METROPOLITAN GOVERNMENT OF NASHVILLE AND DAVIDSON COUNTY

STAFF RECOMMENDATION
1706-1708 Fourth Avenue North
August 20, 2014

Application: Demolition; New construction-infill
District: Salemtown Neighborhood Conservation Zoning Overlay
Council District: 19
Map and Parcel Number: 08205007300
Applicant: Jeremy Leggo
Project Lead: Sean Alexander, sean.alexander@nashville.gov

C2.00

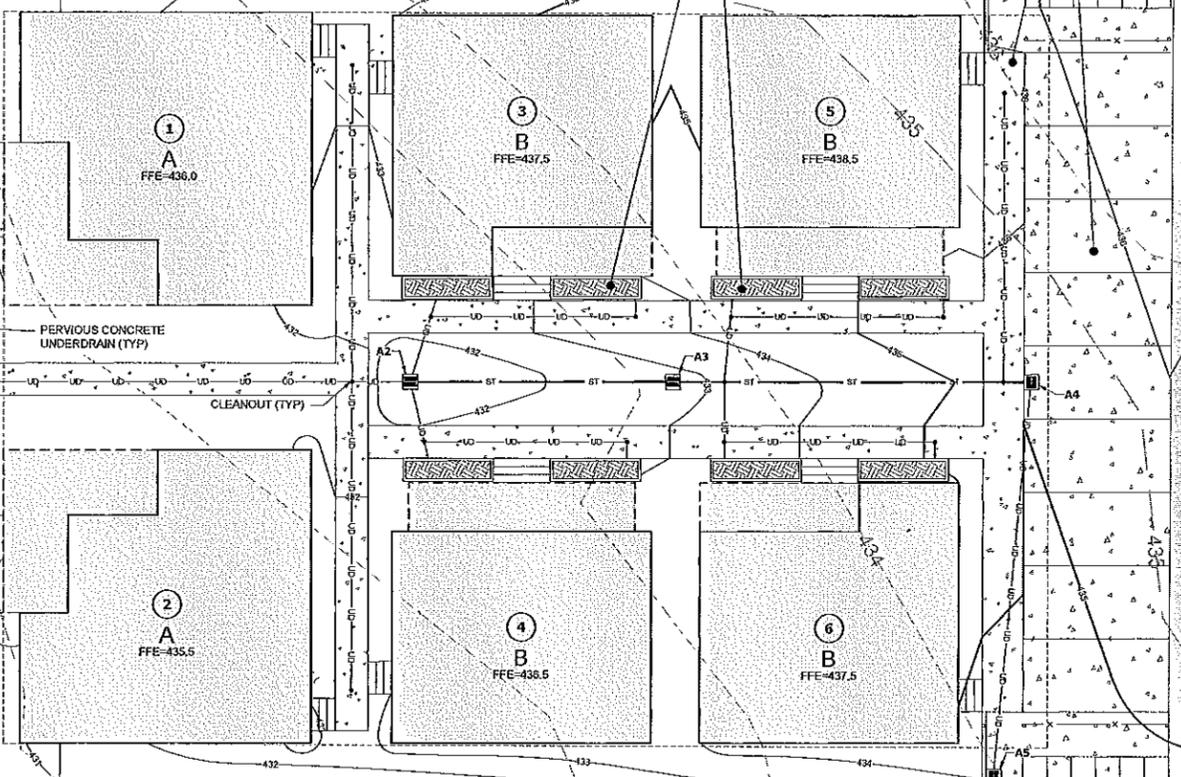
Per the requirements of the SP Zoning Ordinance, a stormwater bioretention feature is required on the lot. This will be a shallow depression in the middle of the central courtyard, with plantings to help shield it from views from the right of way. No other appurtenances were indicated on the drawings. The location of the HVAC and other utilities was also not noted. Staff asks that the HVAC be located behind the two front buildings or on a side façade beyond the midpoint of the front houses. The project meets section II.B.1.i.

**1706A 4TH AVE
ELEVATIONS**

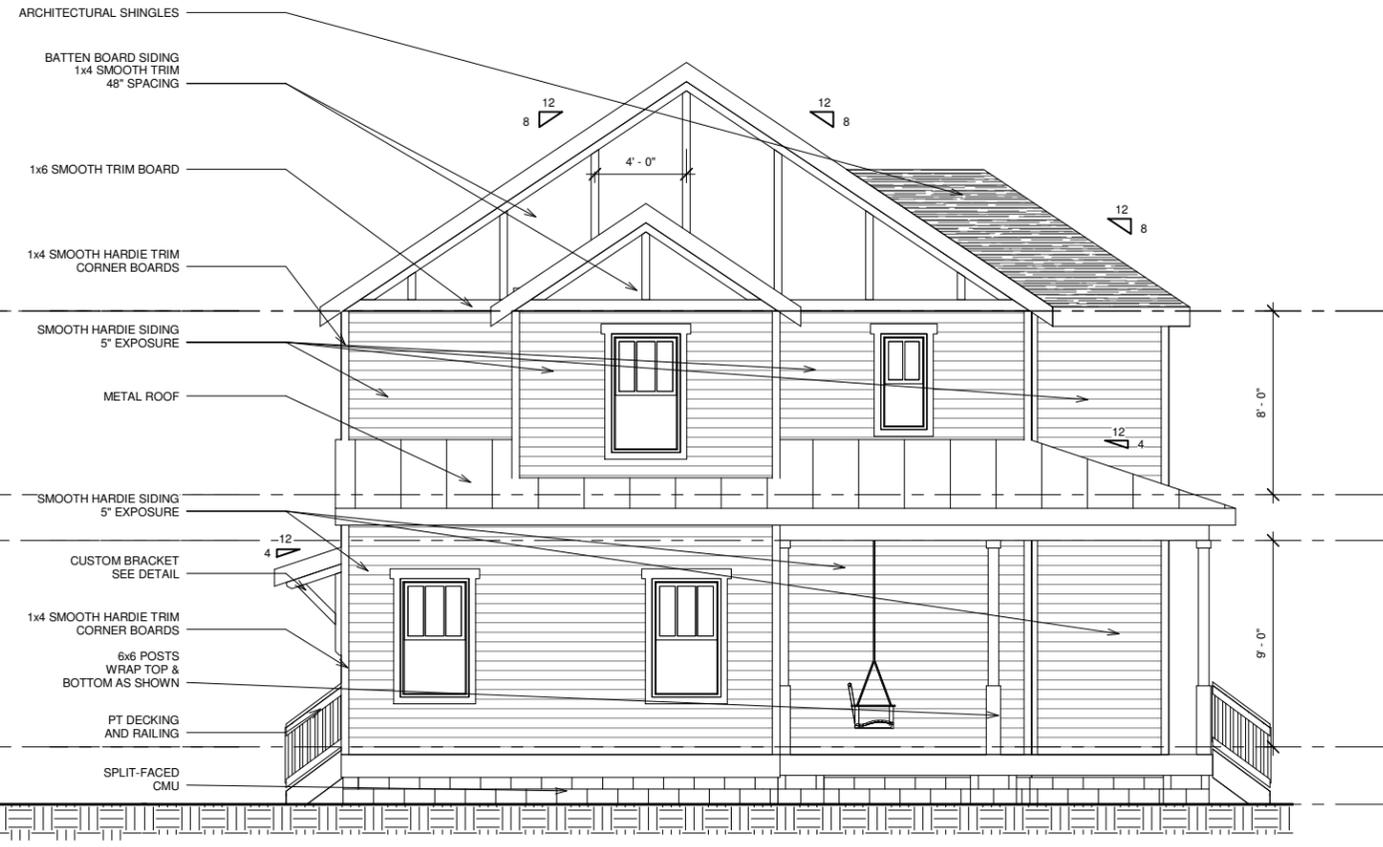
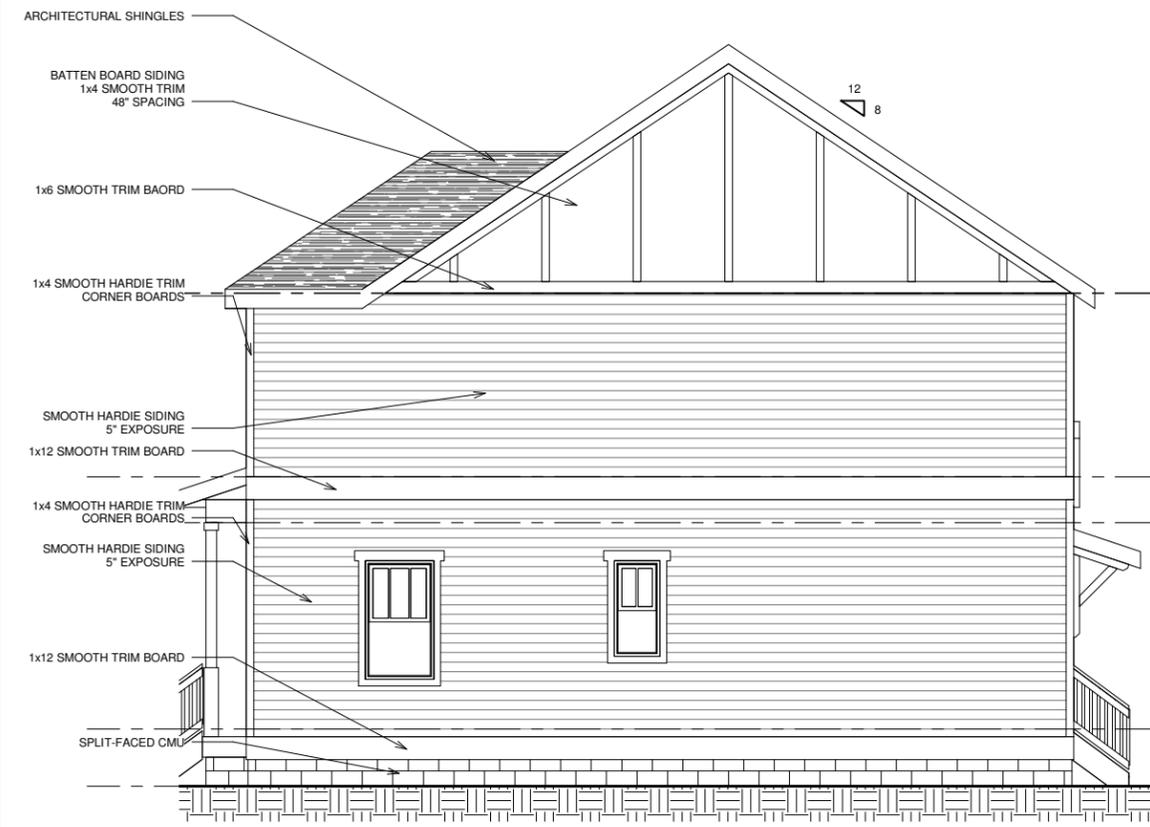
- The finished floor height shall be consistent with the finished floor heights of the adjacent historic houses, to be verified by MHZC staff in the field;
- The heights of the B and C buildings be reduced by five feet (5’);
- Windows are added to the right elevation of building 1706A;
- The roof colors, the materials of the porch floor and steps, the material of the windows and doors, and the material and color of exterior paving are approved by Staff; and
- The HVAC shall be located behind the house or on either side, beyond the mid-point of the house;

The windows on the proposed addition are all generally twice as tall as they are wide, thereby meeting the historic proportions of openings. There are several large expanses of wall space without a window or door opening. The majority of these will be minimally visible but staff does recommend that windows be added to the left side of 1706A on the first floor and on the upper level of the right side; and to the left side of 1708A on the first floor and to the right side on both levels. Because it is at the front of the lot, staff finds that additional windows are necessary to break up the large walls, whereas similarly unbroken walls further back in the lot are less visible. With the additional window described, Staff finds the project's proportion and rhythm of openings to meet Section II.B.1.g.

- The finished floor height shall be consistent with the finished floor heights of the adjacent historic houses, to be verified by MHZC staff in the field;
- The heights of the B and C buildings be reduced by five feet (5’);
- Windows be added to the left side of 1706A on the first floor and on the upper level of the right side; and to the left side of 1708A on the first floor and to the right side on both levels of 1708A;
- The roof colors, the materials of the porch floor and steps, the material of the windows and doors, and the material and color of exterior paving are approved by Staff; and,
- The HVAC shall be located behind the house or on either side, beyond the midpoint of the house.

1706B 4TH AVE
 ELEVATIONS

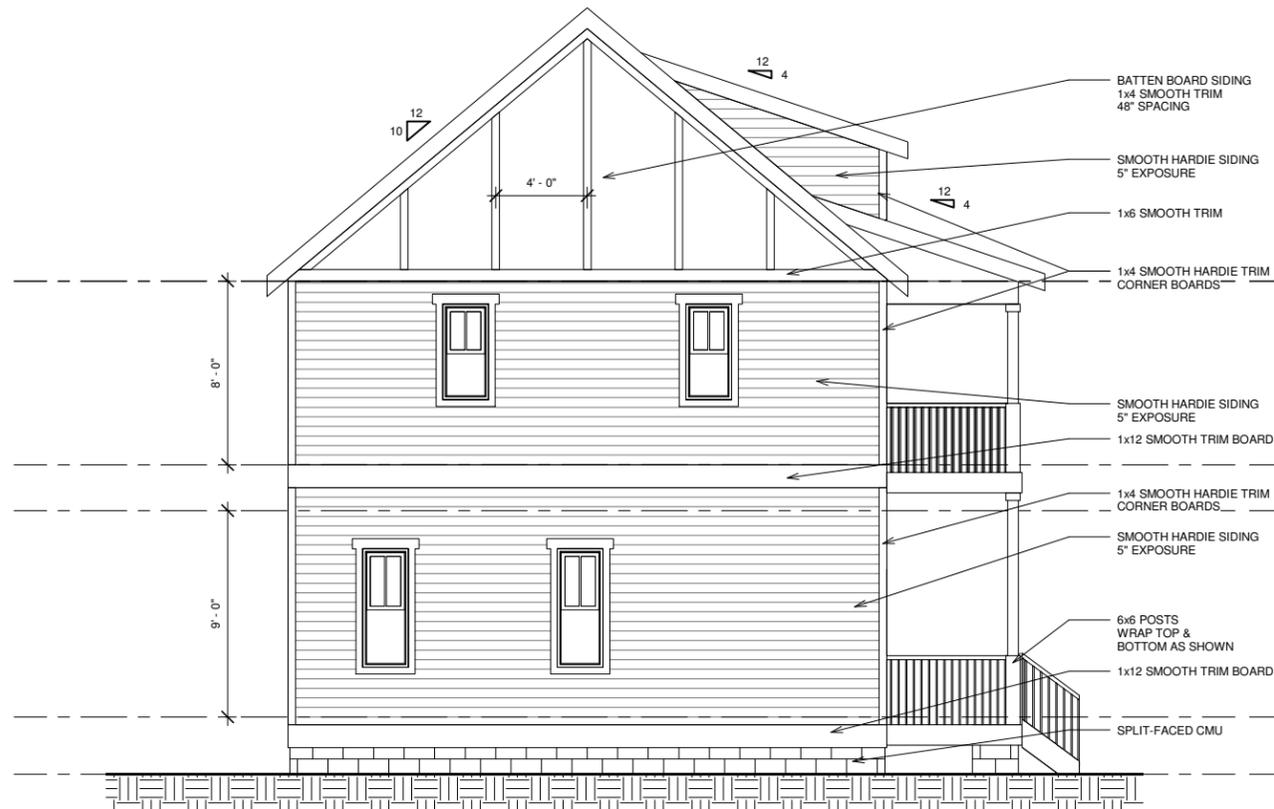
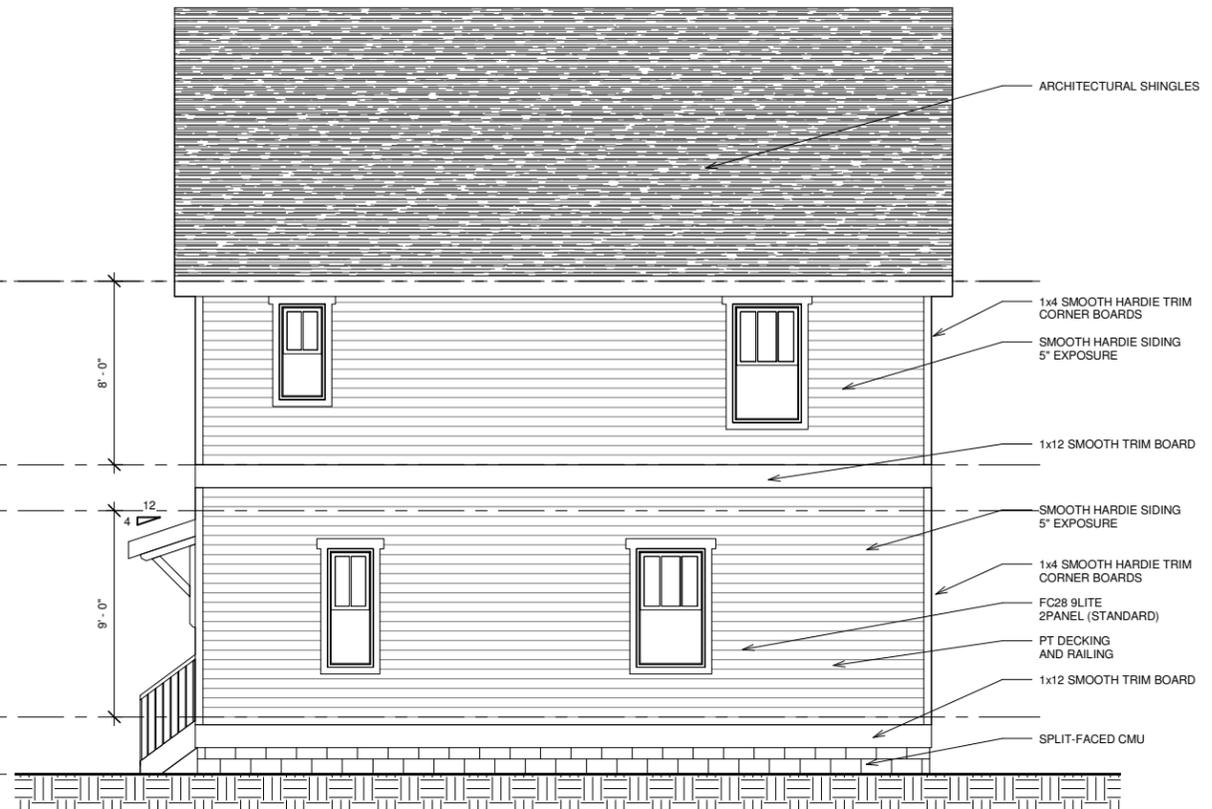
The B and C buildings will be thirty-three feet, six inches (33’-6”) tall, which is two feet (2’) taller than the buildings at the front of the lot. This height difference would be compounded by a rise in the grade of the lot, approximately six feet (6’) from the street to the alley. Although the cottage style development does not have historical precedent in Salemtown, Staff finds that the buildings at the rear should be subordinate to those at the front as this would be more in keeping with the relationships of historic primary and outbuildings buildings in the area. Section II.B.1.k of the design guidelines also requires that interior dwellings on cottage developments be subordinate to street-facing buildings. Staff suggests that buildings B and C be shortened by five feet (5’) to be subordinate to the A buildings.
